Planning & Zoning Board

Thursday, November 7, 2024

Summit Crossing – Major Site Plan, Preliminary Plat, Variance Requests

Date	Job No.
SEPTEMBER 12, 2024	20240202
Scale	Sheet
AS NOTED	1/15

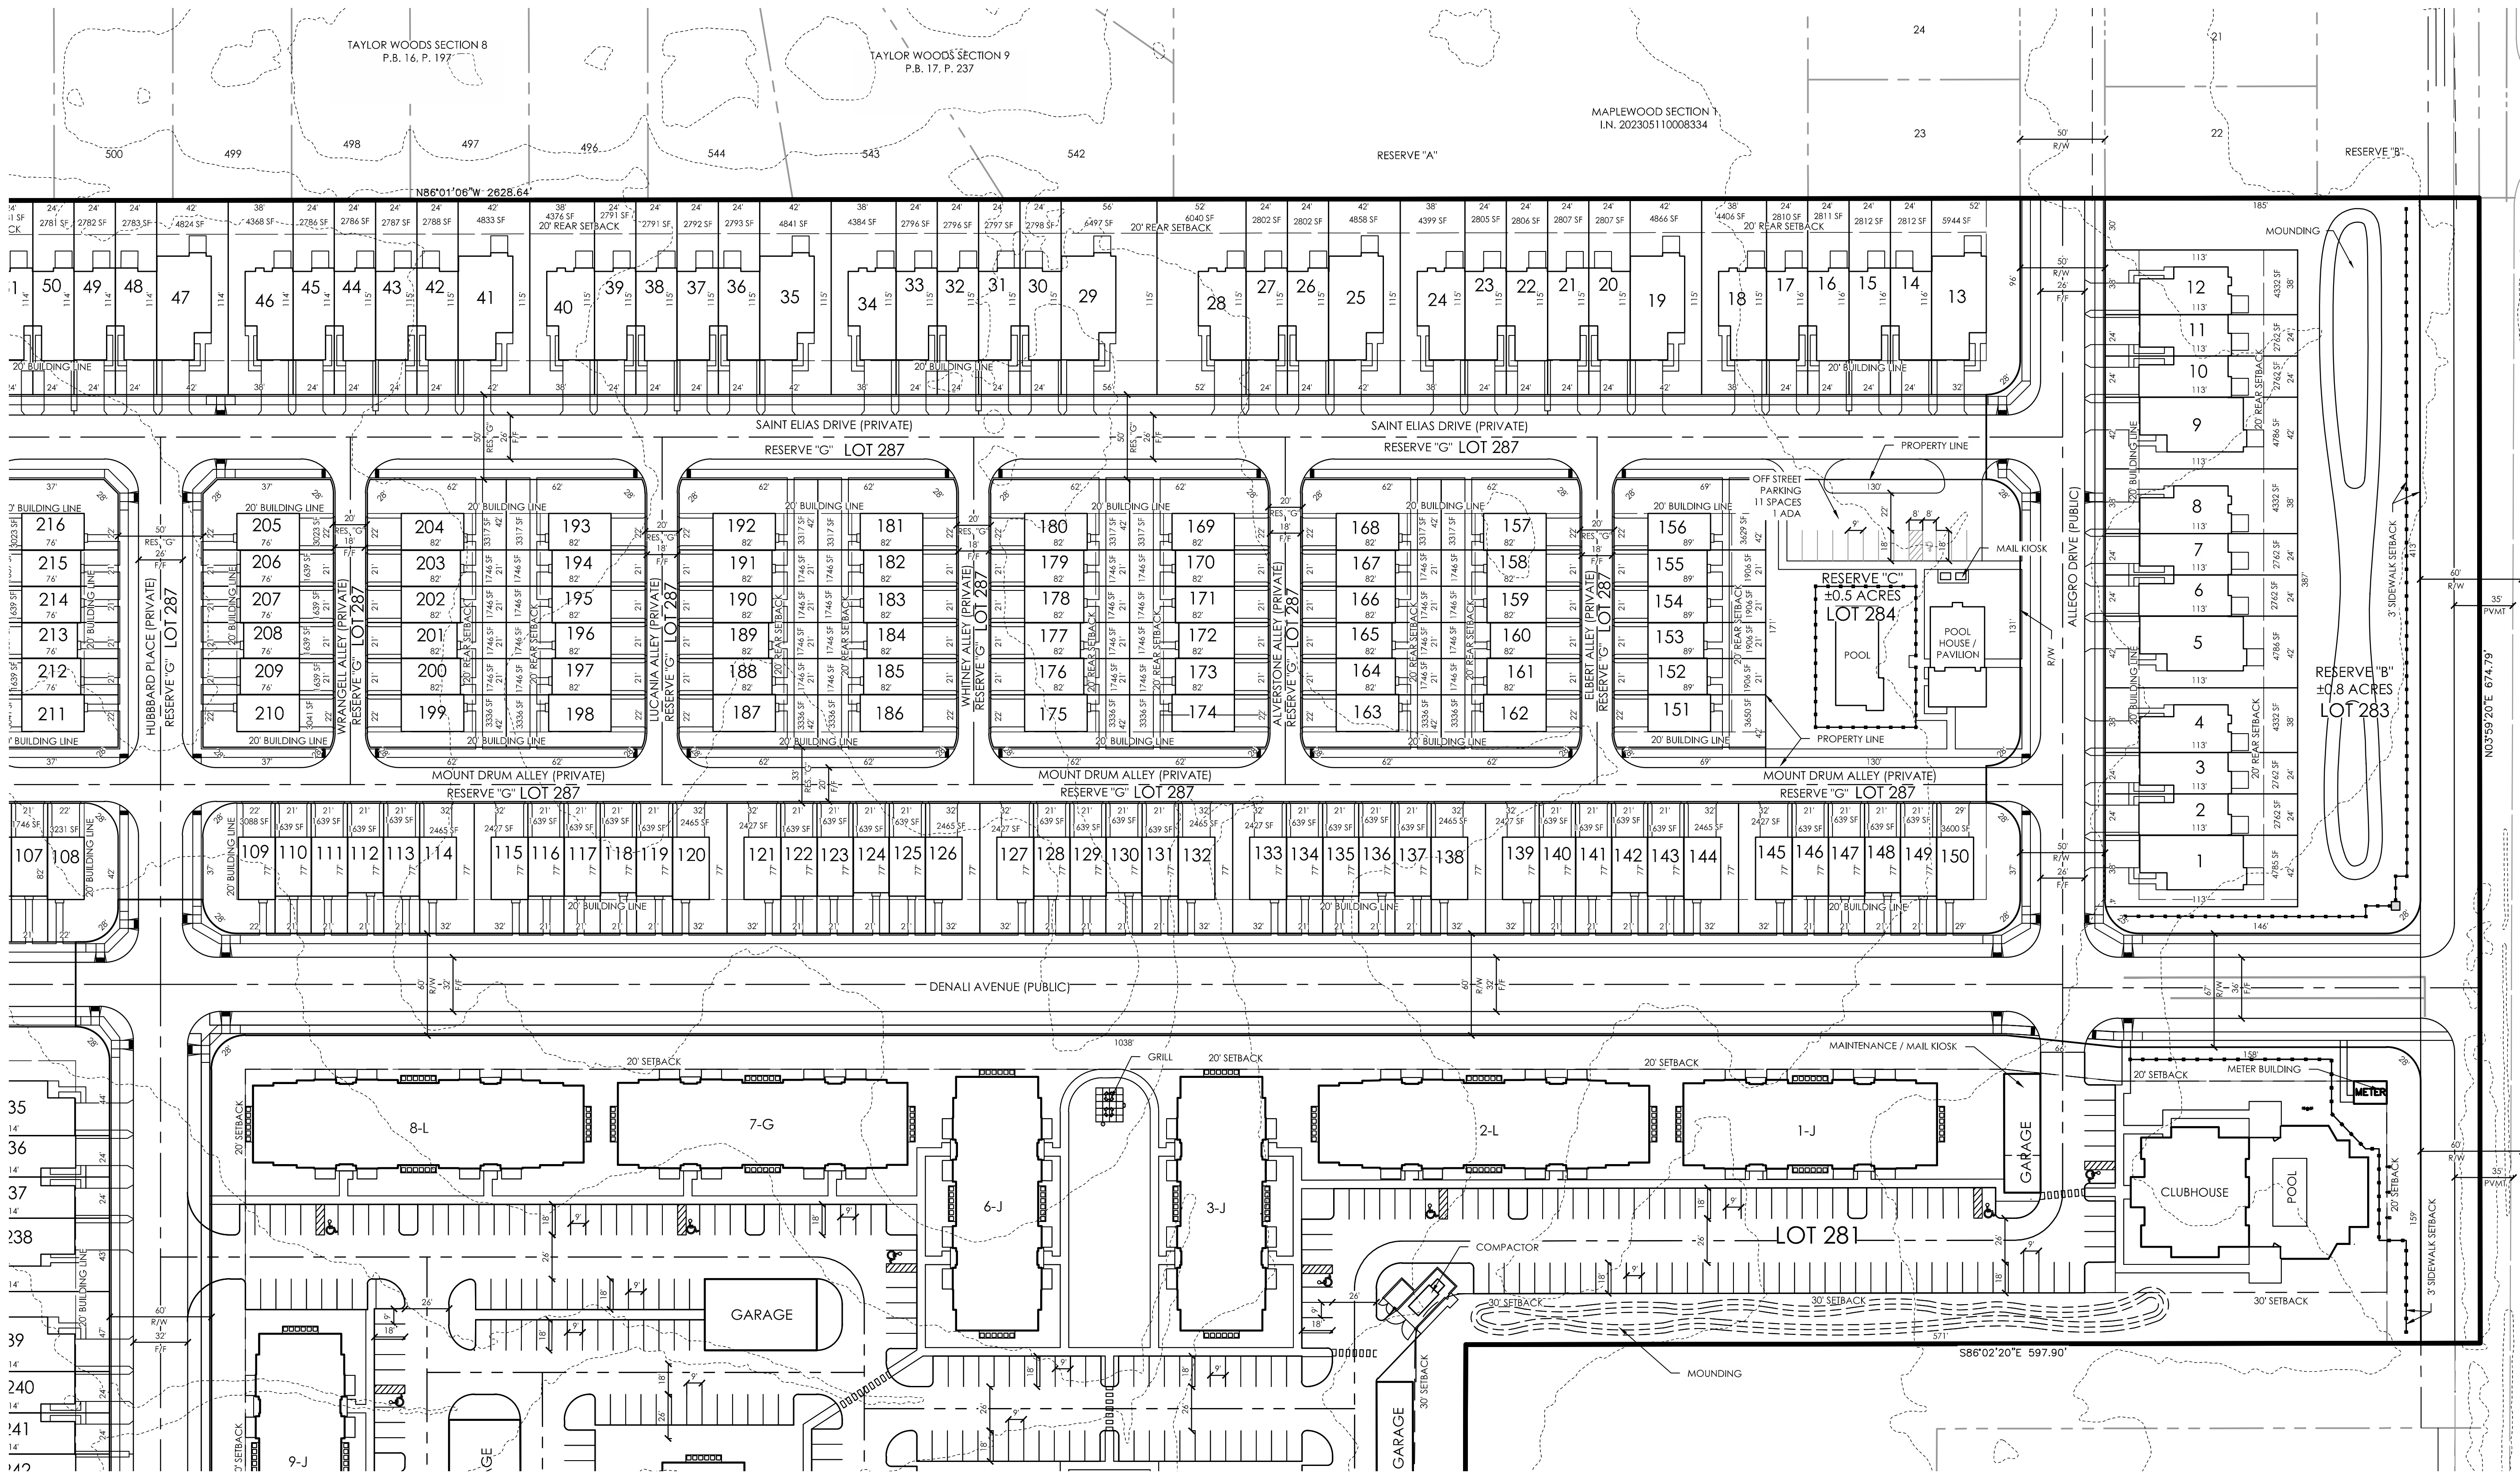
- i. On Sheet 1 of 15 change under Subarea A – Townhomes, “Pool Facility Parking Provided” to 12 spaces.
- ii. On Sheet 1 of 15 change under Subarea A – Townhomes, Pool Facility Parking Provided, “Off Street” to 12 spaces.
- iii. On Sheet 1 of 15 change under Subarea C – Apartments, Parking Provided, “ADA” to 18 spaces.
- iv. On Sheet 1 of 15 change under Notes, Note K, the word “know” to “known”.
- v. On sheet 3 of 15 clarify what RES. G stands for and what the dimensions mean.

Response: See Note "G" on Sheet 1.

Response: See Note "B" on Sheet 1.

Response: See Note "I" on Sheet 1.

Date	Job No.
SEPTEMBER 12, 2024	20240202
Scale	Sheet
1"=50'	3/15

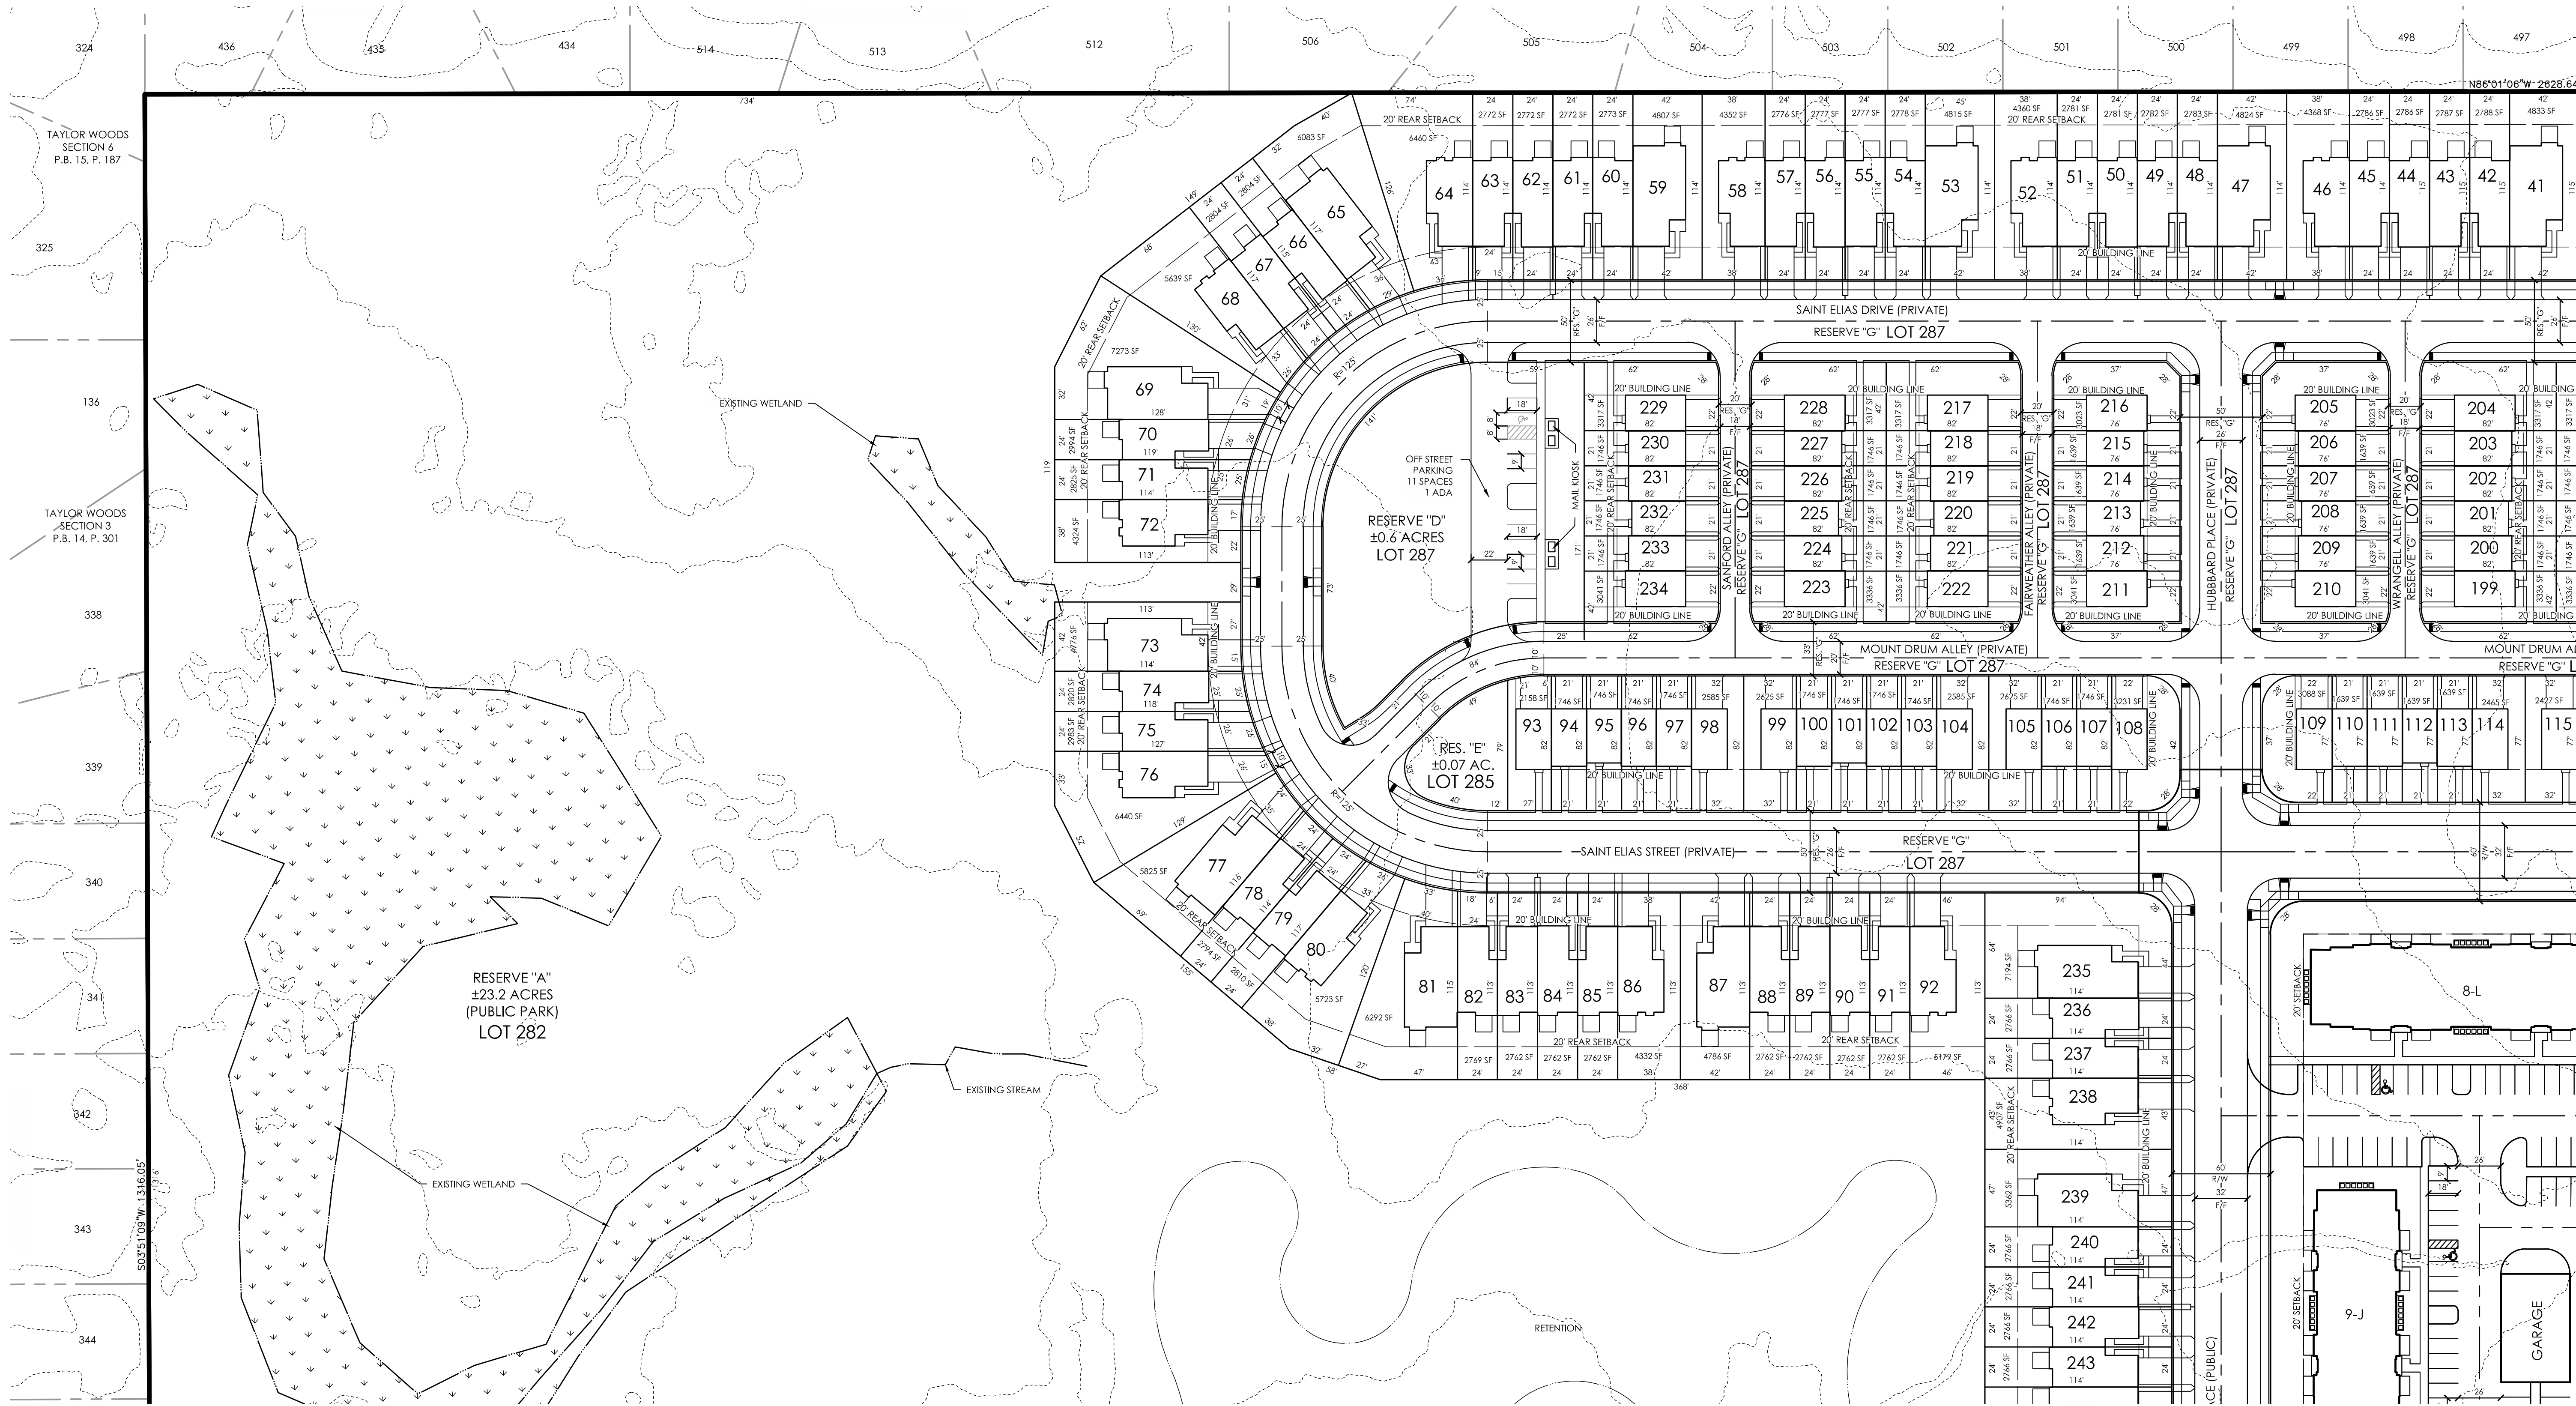
- i. On Sheet 3 of 15, show and meet the required 30 foot rear and 20 foot front setback for “Reserve C”. Section 1111.05.D.iv.4
- ii. On sheet 3 of 15, show the 20 foot front setback along Summit Road and Denali Avenue on Reserve B. Section 1111.05.D.iv.4
- iii. Private Roadways minimum pavement width is 26 feet. The applicant is showing private roadways at 18 feet wide in some areas of the townhome development. The applicant will need to be provided the required private roadway width, or a variance will need to be obtained. Section 1111.15.B.iv

Date	Job No.
SEPTEMBER 12, 2024	20240202
Scale	Sheet
1"=10'	13/15

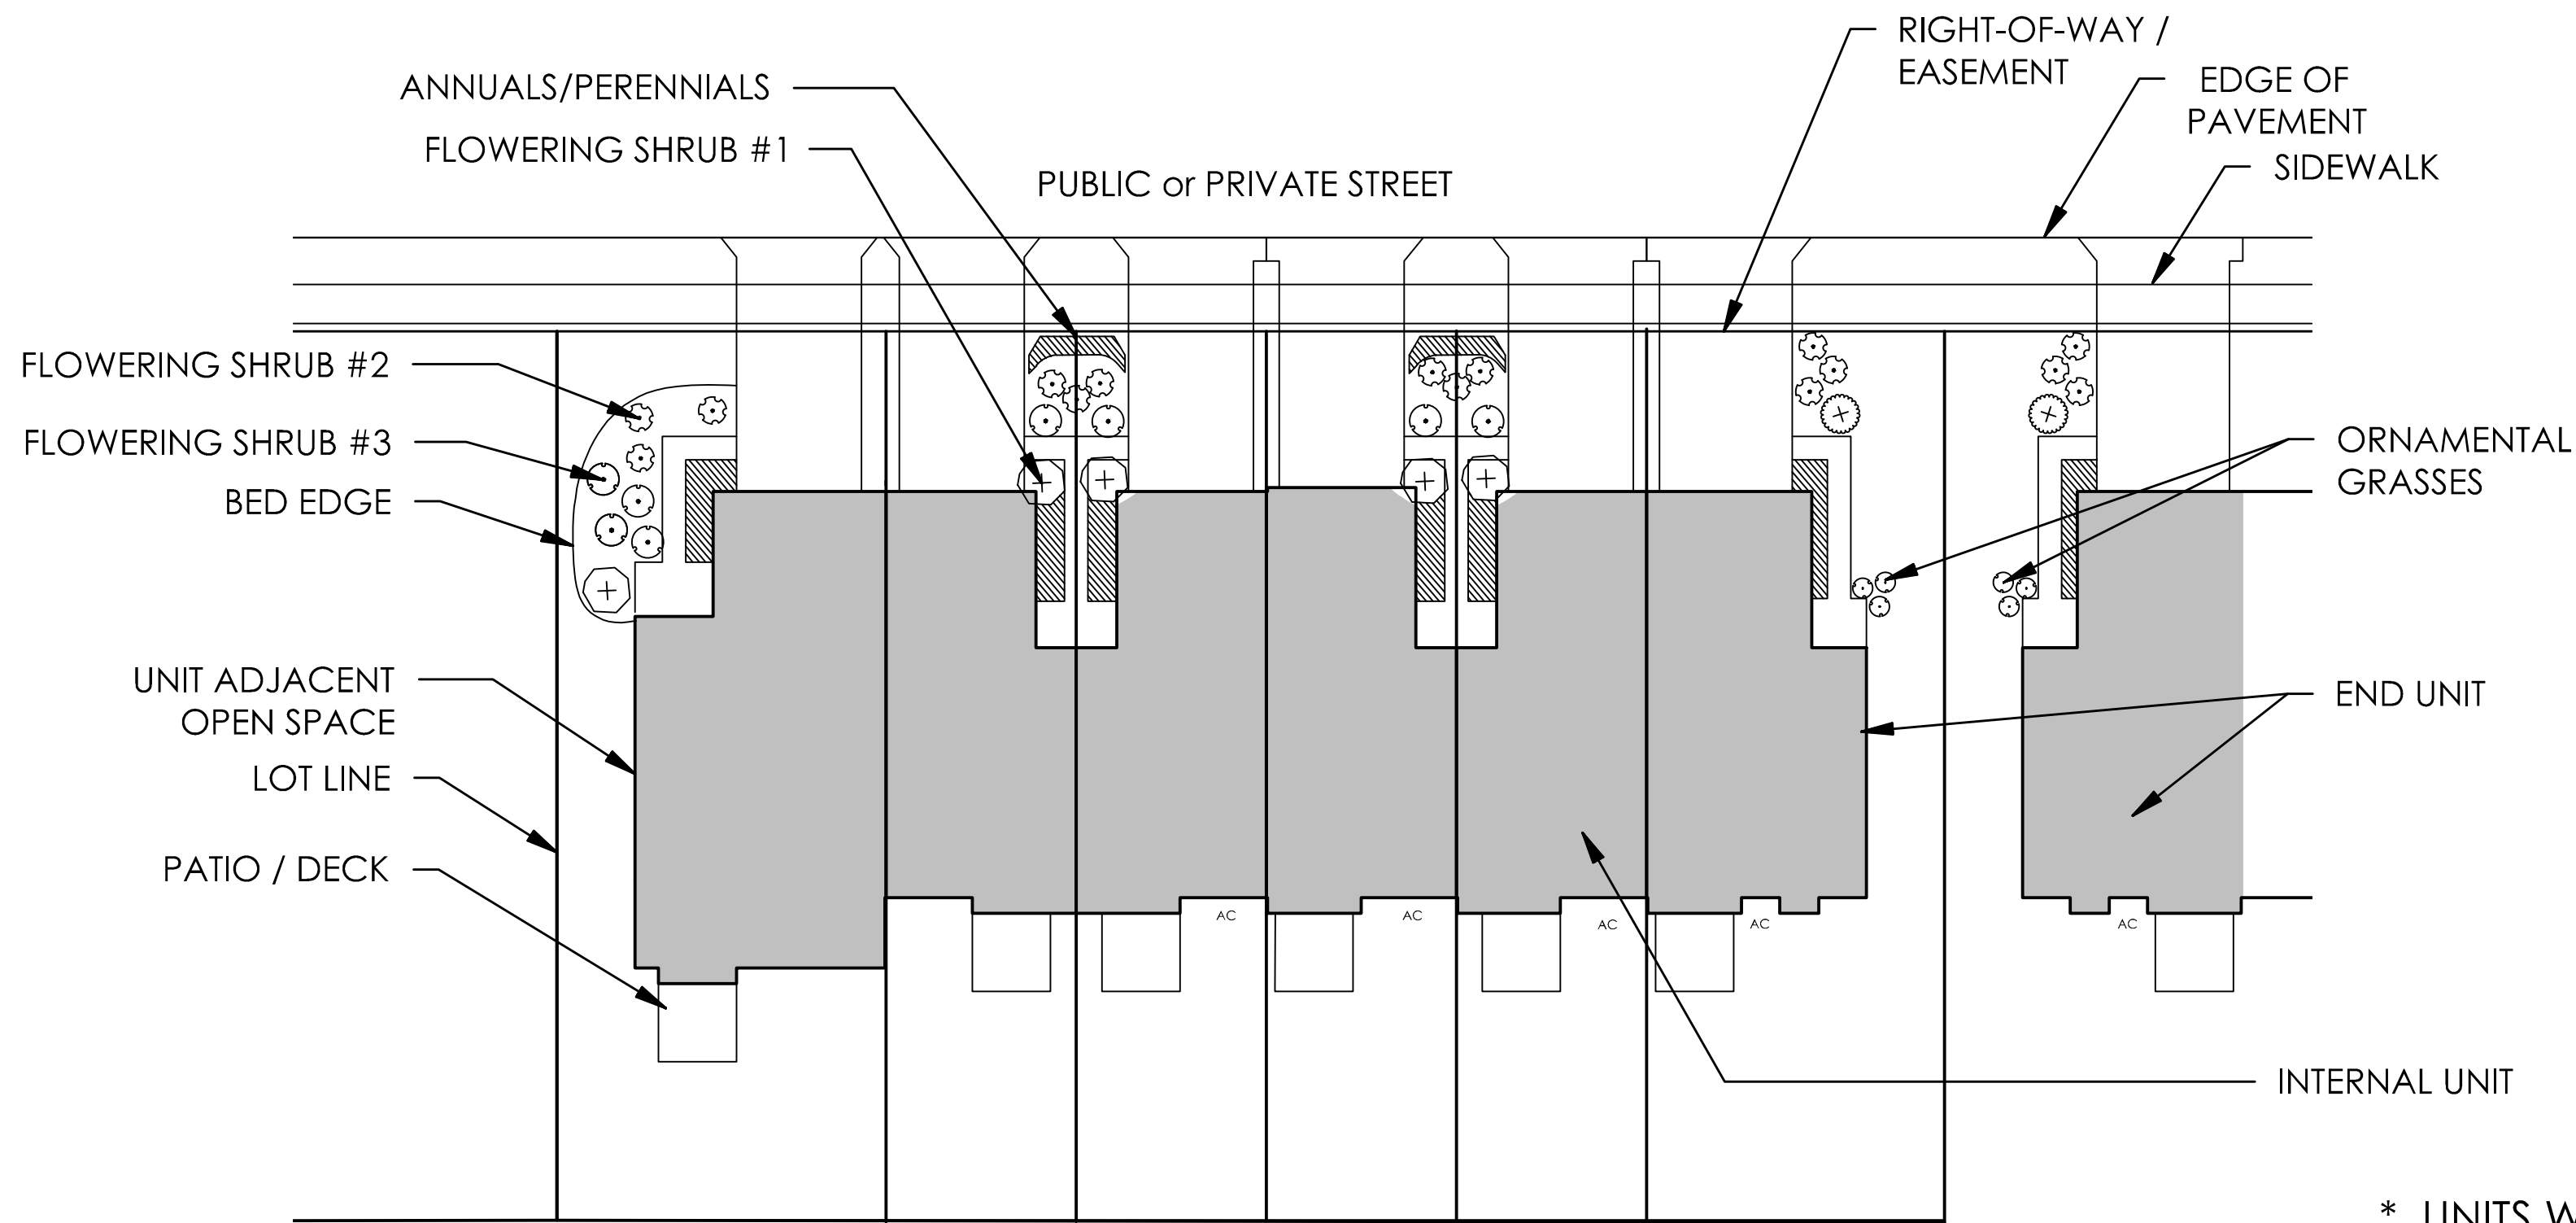
50. The proposed street trees, after looking at the specifications on Sheet 13, appear to actually be interior trees.

52. Sheet 13 with regards to interior lot landscaping will need to meet Section 1105.07.H.i.1. This includes the correct square footage for each lot, including the reserves/other lots that are open space/clubhouse/etc.

56. Remove the not, "**units subject to change based on marketing conditions" from sheet 13.
